APPLICATION FOR PERMISSION
UNDER SECTION 16 OF
THE TOWN PLANNING ORDINANCE
(CAP.131)

For Official Use Only 請勿填寫此欄	Application No. 申請編號	A/SK-HC/328
	Date Received 收到日期	27 JUL 2021

Proposed Small House on
Lot Nos. 1332 S.B in D.D.244

Comments from Relevant Government Departments

Plan No. E289/D/H1/02

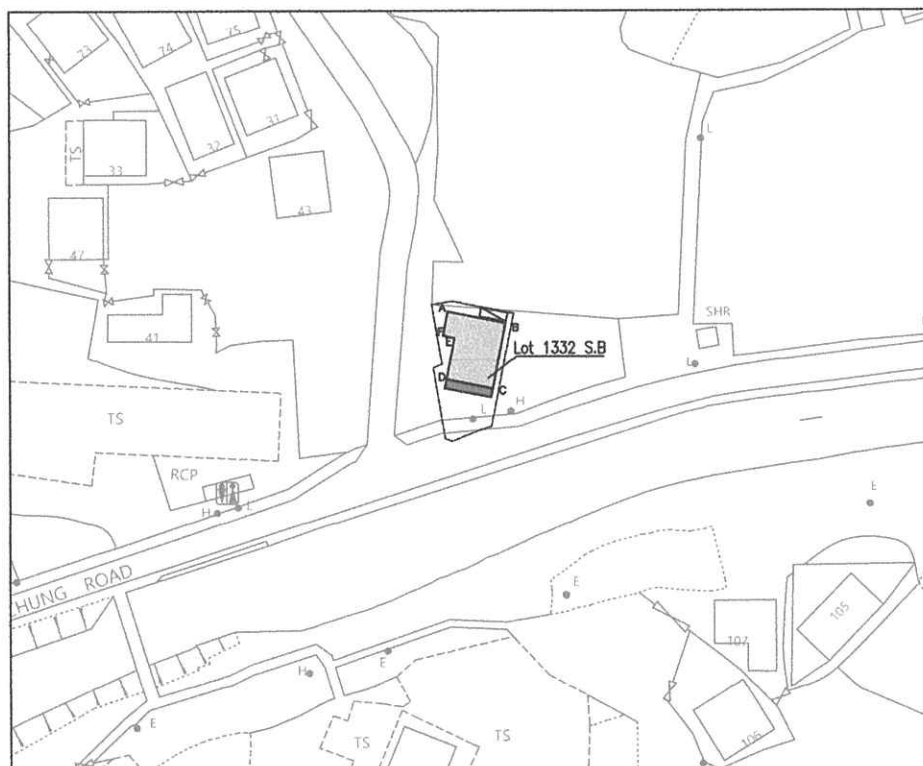
- (a) no objection to the application;
- (b) water mains are in close proximity to the proposed lot and are likely to be affected. The grantee/applicant is required to either divert or protect the water mains found on site;

- (d) if diversion is not required, the following conditions shall apply:
 - (i) existing water mains are affected as indicated on the site plan and no development which requires resiting of water mains will be allowed;

As there is no other house encroaching onto the 'Road' zone close to the junction it would appear that the intention is to provide buffer zone and leave room for upgrade of road?

Applicant should swap the lot for one of the many further back currently used for parking.
